S.S. "SESOSTRIS" NO. 71898 IN THE REGISTER BOOK

Rule dimensions:- 471.08 x 60.66 x 31.25 to Upper Deck  
x 39.25 to Shelter Deck

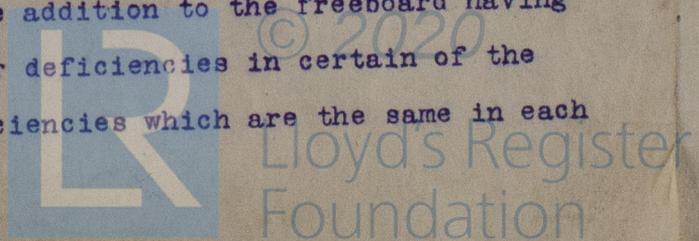
From the scantlings shown on the midship section and from the particulars in the Germanischer Lloyd Register Book it is found that the vessel is a sister ship to the S.S. "AMMON", built by the Flensburg Shipbuilding Co., in 1914.

The scantlings of the S.S. "AMMON" were submitted for classification in December last, and it was found that the vessel was eligible for the class 100A "Shelter Deck with Freeboard", a suitable addition to the freeboard having been made to compensate for deficiencies in certain of the scantlings etc. These deficiencies which are the same in each

vessel are as follows:-

- Inner bottom .04"
- Outside plating .08"
- Upper deck plating .06"
- Upper deck stringer plate .16"

It is submitted that Messrs. Harris & Dixon be informed that the scantlings and arrangements, as far as shown on the midship section forwarded by them, have been examined and compared with the requirements of the Rules, and that it is found there are deficiencies in certain of the scantlings. To compensate for these an appropriate increase will be made in the freeboard.

Subject to the vessel being surveyed in accordance with Section 48 of the Rules for vessels not built under the Society's survey and being favourably reported upon both in this respect and in regard to such arrangements as are not shown on the plan of midship section, the vessel could be recommended to the Committee for the class 100A- "Shelter Deck" with Freeboard.
